### TUALATIN ARCHITECTURAL REVIEW BOARD SEPTEMBER 20, 2017, 6:30 PM POLICE TRAINING ROOM 8650 SW TUALATIN RD TUALATIN, OR 97062

The following conditions are highlighted as they could result in adjustments to the Site Plan, Sheet C1.1 (dated July 28, 2017):

SITE LIGHTING PLAN

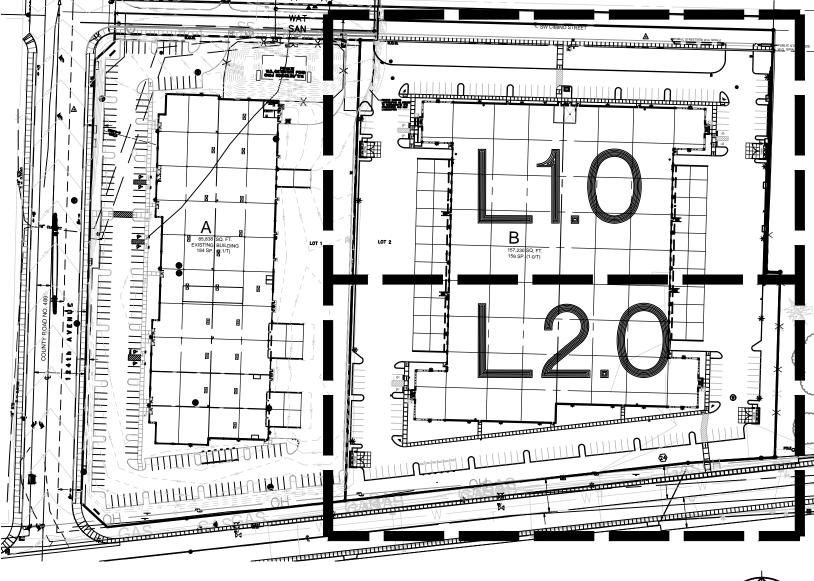
While the proposed lighting would not result in impacts to natural resources/areas and would not impact adjacent right-of-ways (SW Tualatin-Sherwood Road and the Cimino Street extension), Sheet LT1.0 Site Lighting Plan (dated July 28, 2017) shows lighting extending as far as 70 feet into the neighboring residential property at 12075 SW Tualatin-Sherwood Road to the east As existing structures on this adjacent residential property are located as close as 90 feet from the property, the proposed lighting plan has the potential to impact this property. Staff recommends a condition of approval to meet the standard.

<u>Condition of Approval:</u> The applicant shall modify the proposed lighting plan to include lighting on the eastern portion of the project site that does not shine onto the adjacent residential property at 12075 SW Tualatin-Sherwood Road and illustrate the results of these modifications on Sheet LT1.0 Site Lighting Plan pursuant to TDC 73.380(6).

<u>Condition of Approval</u>: The applicant shall install lighting as shown on the site lighting plan (Sheet LT1.07) to ensure that the proposed development will not result in excess lighting and will continue to meet the lighting standards of TDC 73.160(3)(c).

LANDSCAPE PLAN 'A'

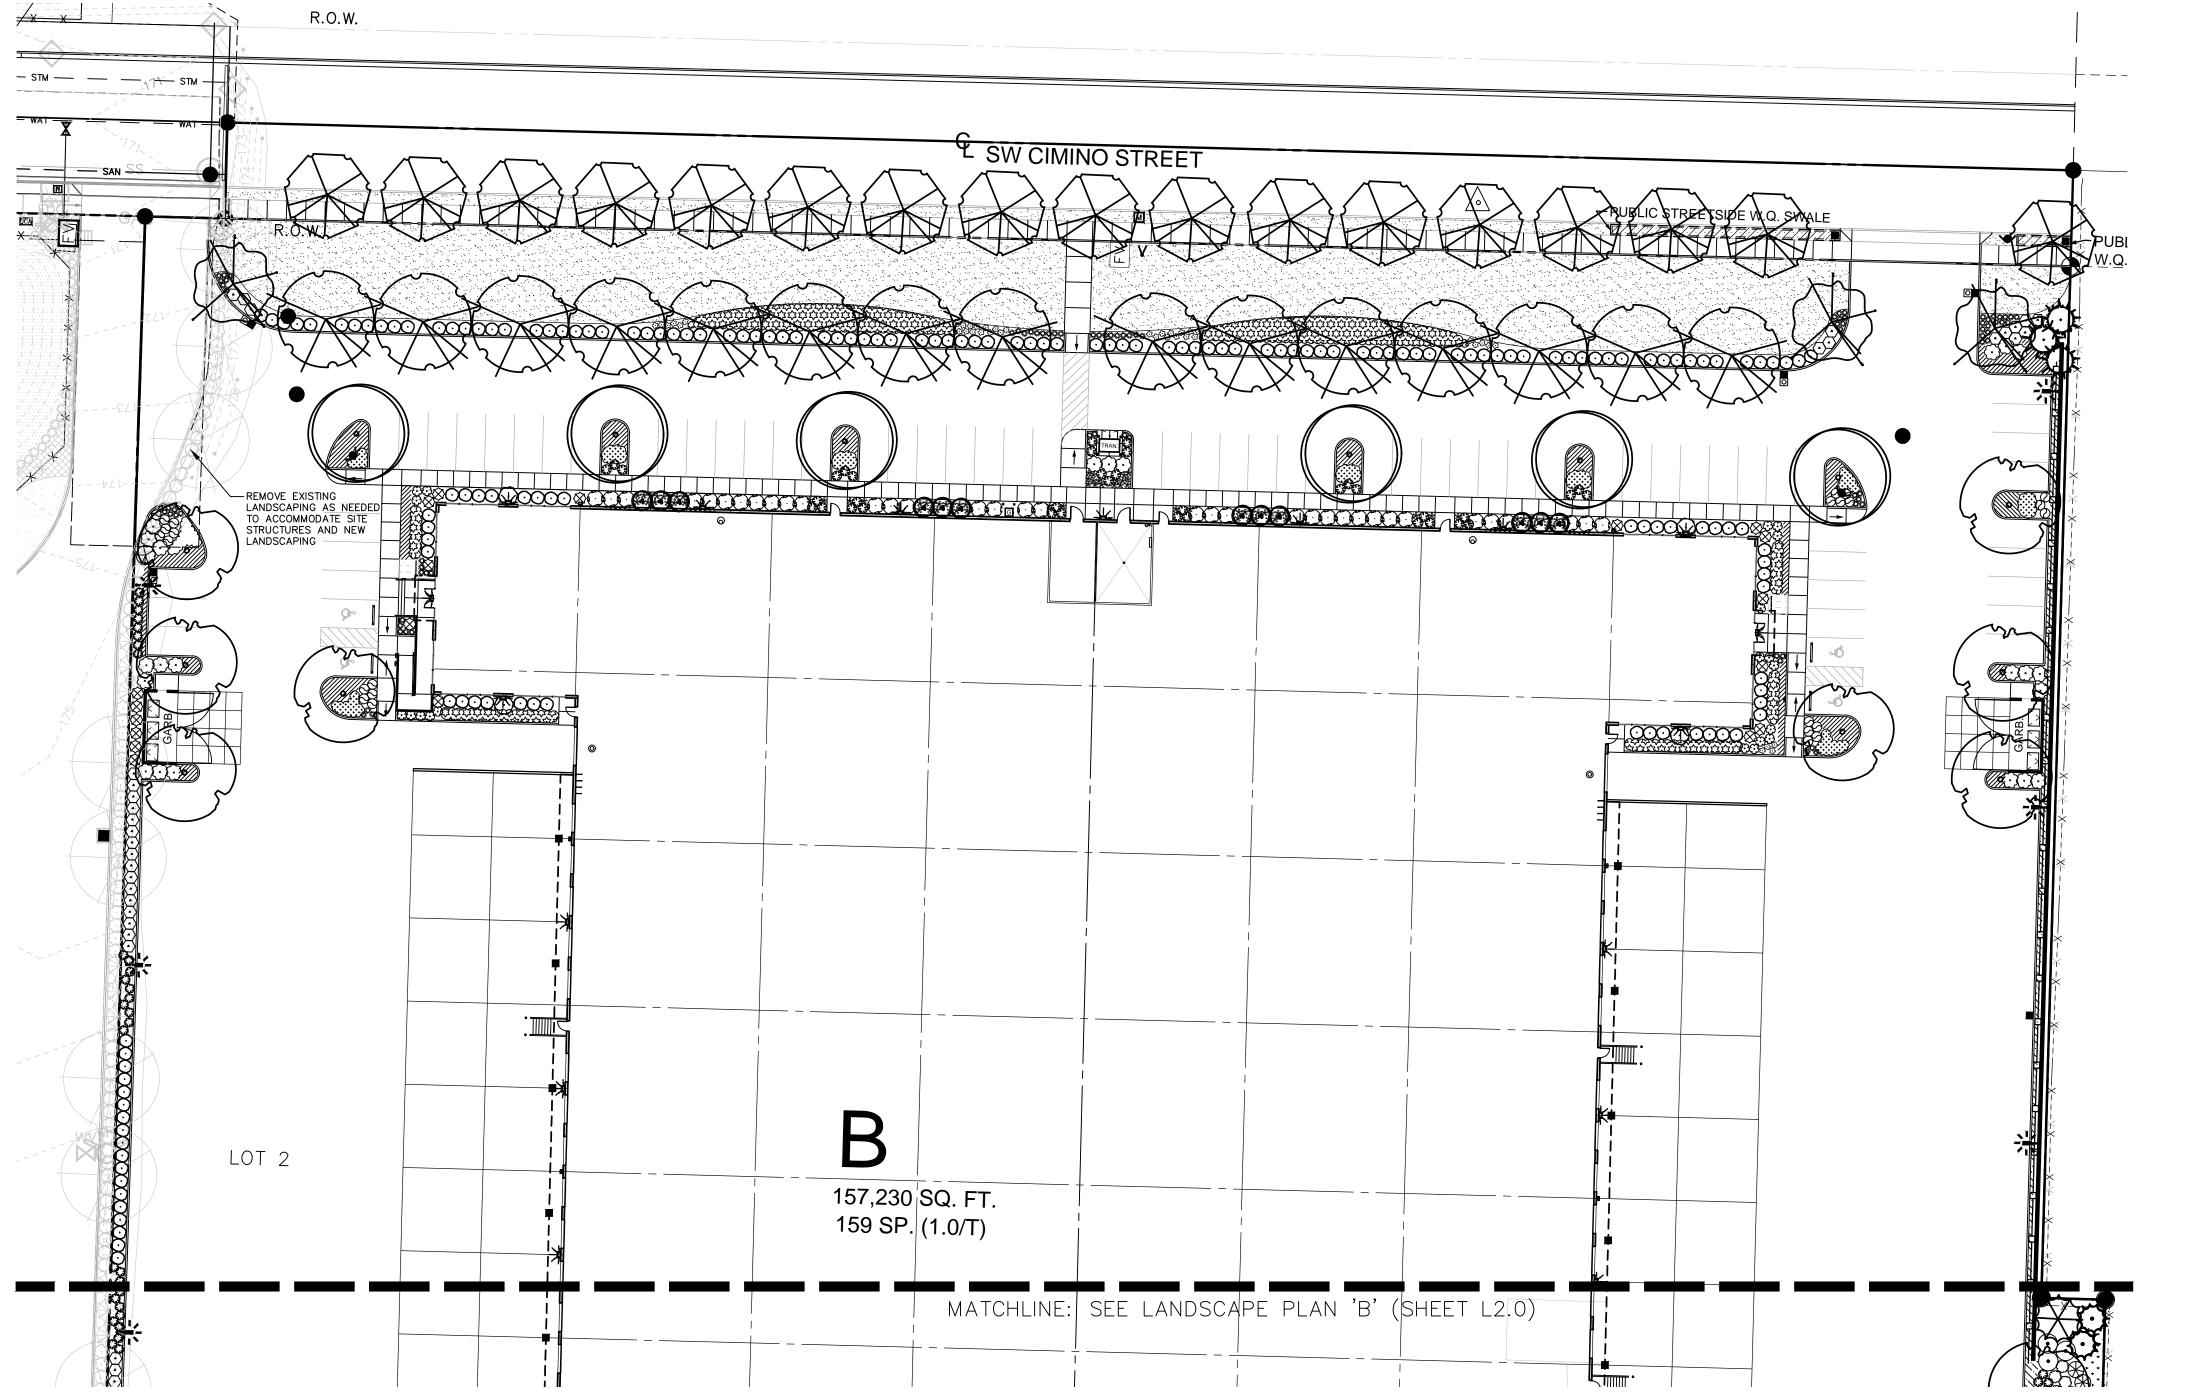
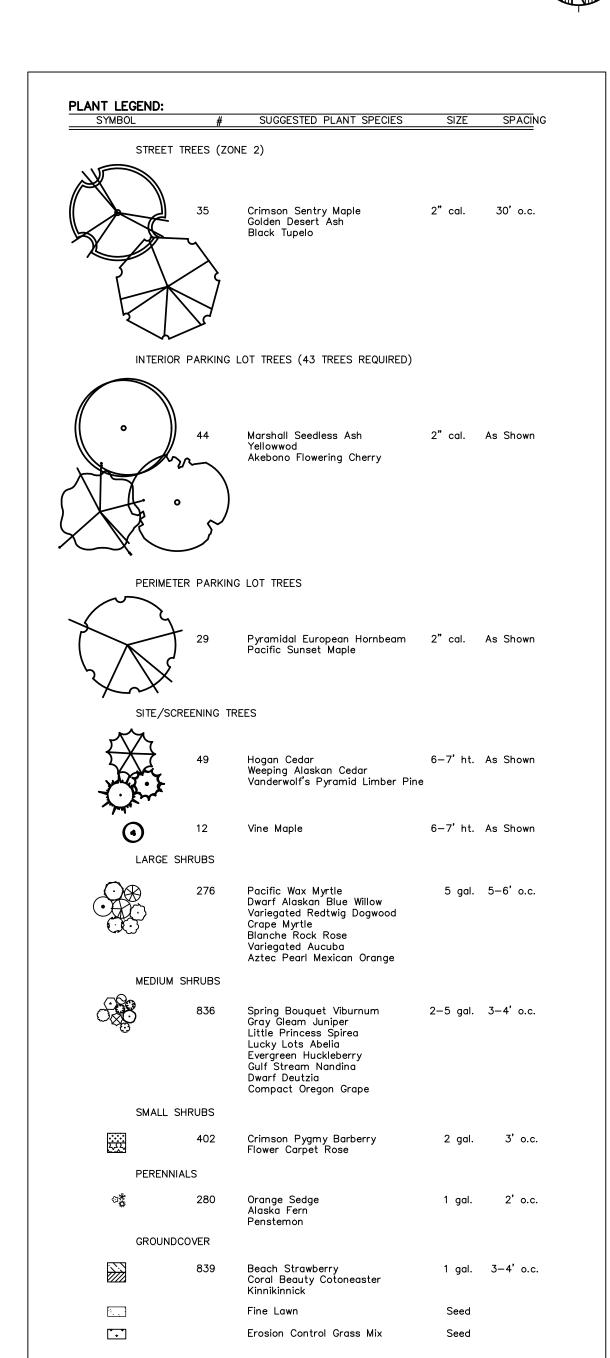
Staff finds that clear zones are shown on Sheets L1.0 and L2.0 Landscape Plan (both dated July 28, 2017) for the ends of on-site drive aisles in the parking and circulation areas. However, vision clearance areas

<u>Condition of Approval</u>: The applicant shall revise Sheet L1.0 Landscape Plan to illustrate vision clearance areas at the SW Cimino Street access driveways and revise the landscape plan as necessary to create clear zones pursuant to TDC 73.340(1).
